THE ABBOT BUILDINGS

PLANNING BOARD SUPPLEMENTAL FILING

MEMORANDUM 1

RE: Response to 01.30.2018 Planning Board hearing and
02.14.2018 meetings with CDD and Historic Commission

REVISED LEVEL 4

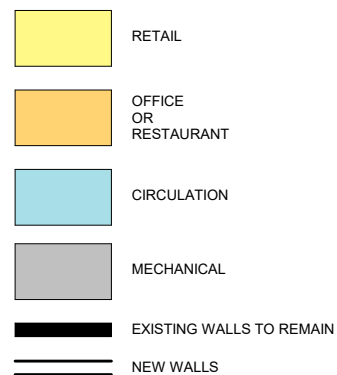
To provide more opportunity for the active uses of the 4th floor to be more apparent; study expanding the extent of the proposed roof deck.

The 4th floor roof deck area has been revised to extend over the Brattle building and also wraps the corner to enable active uses to be visible and overlook Brattle Square.

JFK ST. ELEVATION (01.30.2018 PROPOSAL)

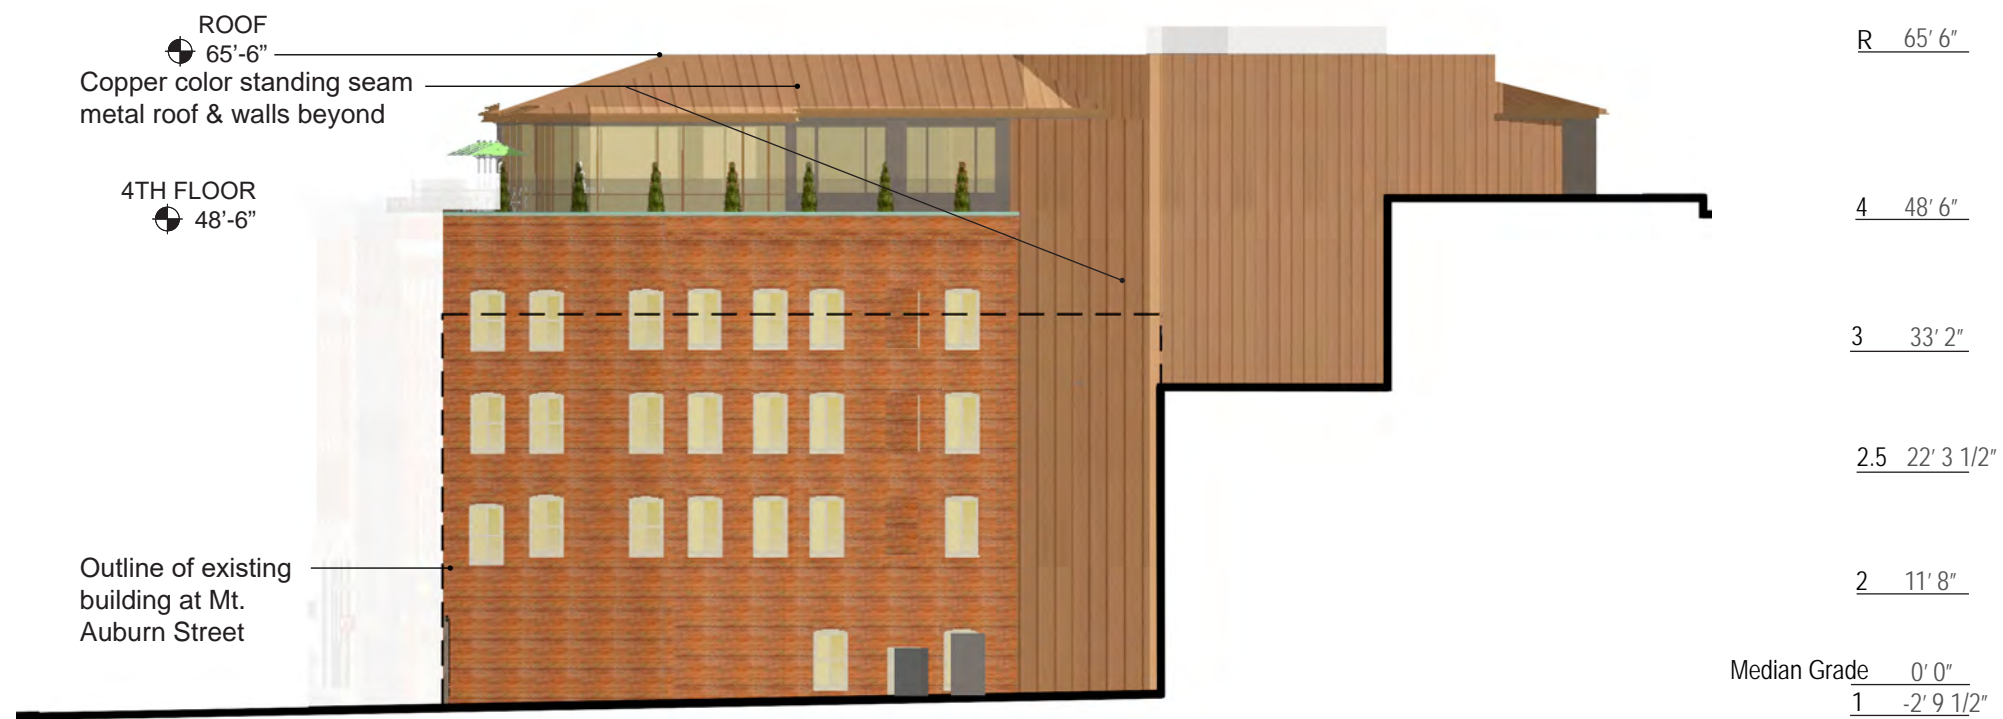
The recessed brick bay in the center of the JFK façade seemed unnecessary. The interrupted storefront would be more difficult to sub-divide.

Along JFK Street, the glass façade adjacent to 39 JFK Street has been changed to a brick and glass façade.

The revised design has eliminated the center bay recess and simplified the façade design along JFK Street enabling more flexible retail tenancy.
